**DOE Moab UMTRA Responses to  
Nuclear Regulatory Commission (NRC) Staff Comments on  
“Crescent Junction Disposal Site Alternative Final Cover System  
60 Percent Design Report”**

By letter dated August 30, 2021, the U.S. Department of Energy, Office of Environmental Management (DOE-EM) and Moab Uranium Mill Tailings Remedial Action Project submitted for the U.S. Nuclear Regulatory Commission (NRC) staff’s review and comment, a report titled, “Crescent Junction Disposal Site Alternative Final Cover System 60 Percent Design Report,” (Design Report) (NRC Agencywide Documents Access and Management System Accession Number ML21243A286). Consistent with the approach used in the review of the 2008 Remedial Action Plan (RAP) (ADAMS Accession Number ML080920459), the NRC staff’s review process was informed by the “Final Standard Review Plan (FSRP) for Uranium Mill Tailings Radiation Control Act Title I Mill Tailings Remedial Action Plans” (ADAMS Accession Number ML110190562) and more recent applicable technical guidance in NUREG-1620, “Standard Review Plan for the Review of a Reclamation Plan for Mill Tailings Sites Under Title II of the Uranium Mill Tailings Radiation Control Act of 197

Figure 7-8. Transition of Disposal Cell Top Cover to Side Slopes

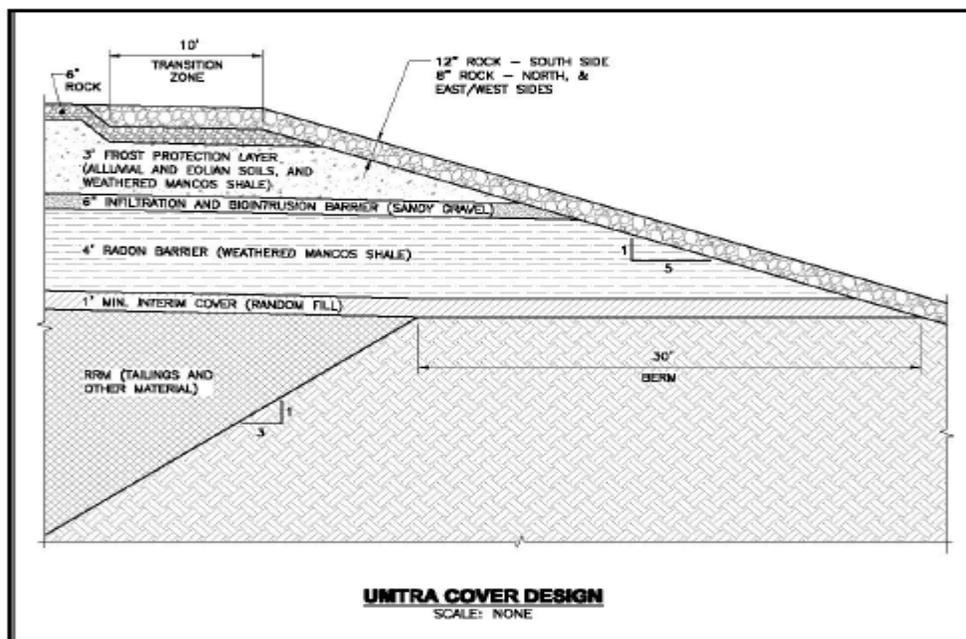
- Section 5.1.1, "Cover Thickness and Layer Data," states, "Two different surface admixture thicknesses (18 inch and 24 inch) were computed dependent on the slope lengths (Figure 5)." Consider adding a figure similar to FRAP Figure 7-8, "Transition of Disposal Cell Top Cover to Side Slopes," to show the final alternative cover profile where the top cover transitions to the side slopes.

**Moab Response:** A final decision has not been made on the cover profile - whether multiple profiles or a single profile will be used. Given that we will consider adding the suggested figure to the report in the 90% submittal.
